Public Service Commission
-M-E-M-O-R-A-N-D-U-M-

DATE: December 5, 2003
TO: Mary Bane, Executive Director
FROM: Division of Economic Regulation (Breman) *JB 12/5/03*
RE: Request for Change of Recommendation Filed December 4, 2003, Docket No. 030834-EI.

RE: DOCKET NO. 030834-EI - REQUEST TO EXCLUDE OUTAGE EVENT
FROM ANNUAL DISTRIBUTION SERVICE RELIABILITY REPORT FOR
CALENDAR YEAR 2003, BY PROGRESS ENERGY FLORIDA, INC.

ISSUE 1: Should the Commission approve PEFI's amended petition to exclude from its 2003 Annual Distribution Service Reliability Report 9,220 service interruptions that occurred in PEFI's North Central Region on July 18, 2003?

System Daily Flash Count

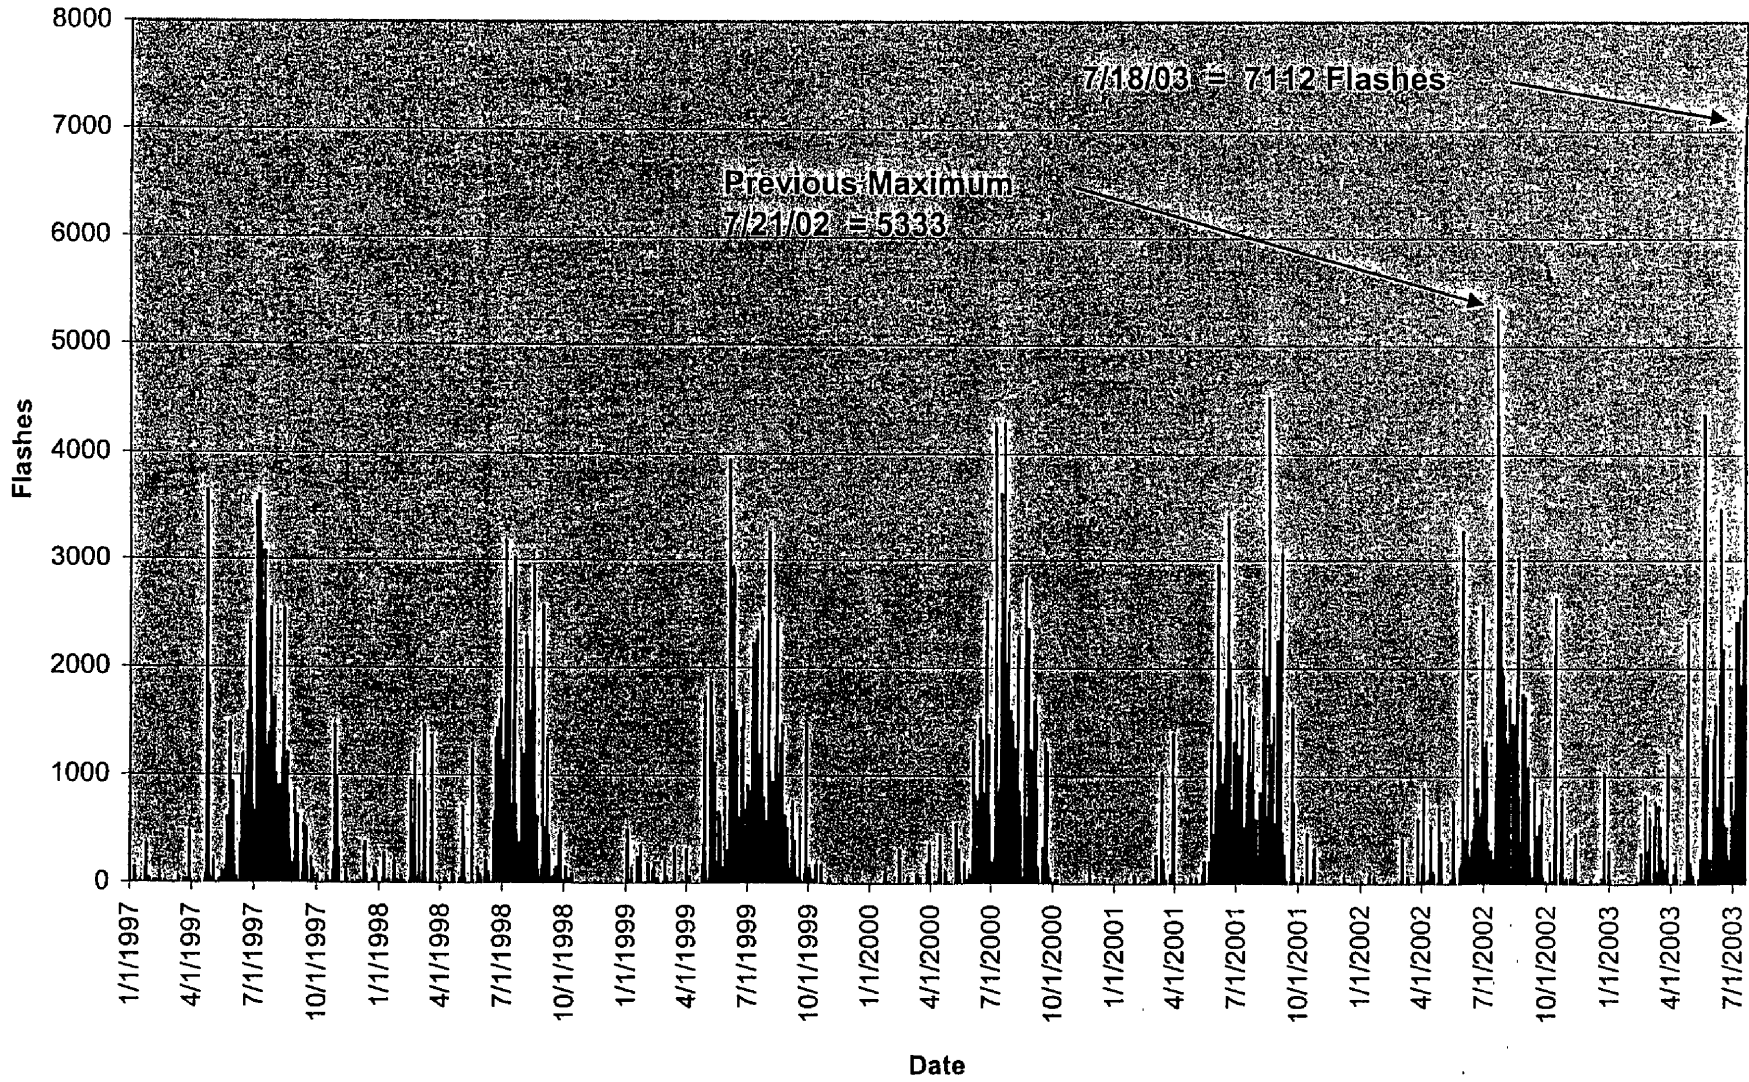
As previously discussed, the lightning flashes reported in PEFI's data could potentially double because the level of lightning that typically occurs in central Florida is at least twice what PEFI has recorded within the footprint of its facilities. PEFI's graph of system daily lightning flash counts is shown in Attachment 1 to this recommendation. Staff notes that PEFI's chart clearly shows an increasing trend in the number of lightning strikes within its service area for each year since 1999.

Pursuant to the IEEE White Paper, PEFI should have implemented changes in its operating practices when PEFI began to notice an increasing trend in the intensity of weather patterns as seen in Attachment 1. Instead, as previously discussed, PEFI makes no specific effort to find and replace failed lightning arresters. PEFI elects to have fewer lightning arrester stations in lightning prone areas compared to other utilities. Furthermore, PEFI's 10-year inspection cycle may not be sufficient to address changes in weather patterns. In this instance, PEFI's proposed use of statistics to achieve an exclusion conflicts with the IEEE White Paper because PEFI has not demonstrated its actions have been the appropriate response to the observed weather patterns.

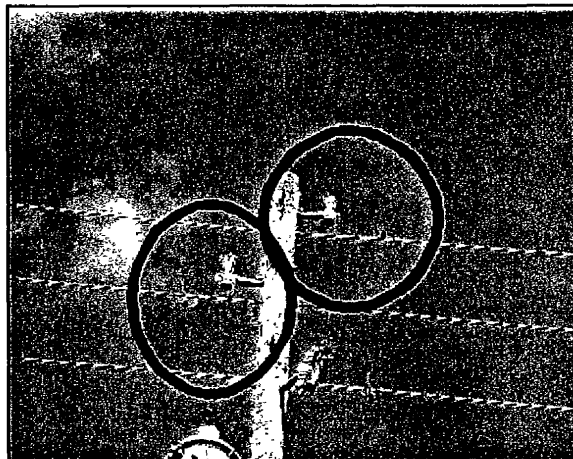
Velazquez No. 6: Next to pole 136062-045422 on Poinciana Pkwy approximately 2/10 of mile south of Lake Marion Creek Dr. Bottom of lightning arrester on top phase has failed. Note: The grounding conductor wraps around the highest insulator on the front side of the pole with the lightning arrester connection resting on top of the insulator. The grounding conductor-arrester connection can fall from its perch on the insulator and come in contact with the stinger wire of the top phase and cause a phase to ground fault on that phase.
